TECHNICAL INFORMATION COMMUNICATION

Number: TIC2021-0014

Title: Furnace Motor Coast Down Noise

Product Category: Cooling Products

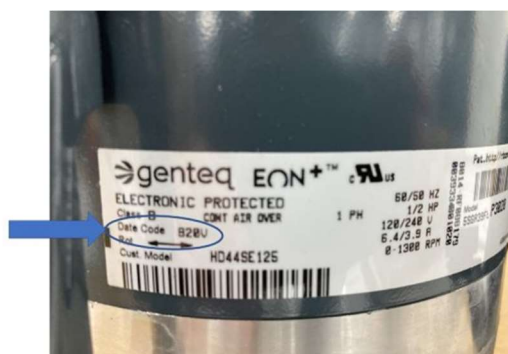
How to identify the motor date code:

The Date Code below indicates
it has a serial number:
B20V
Feb of 2020 build date.
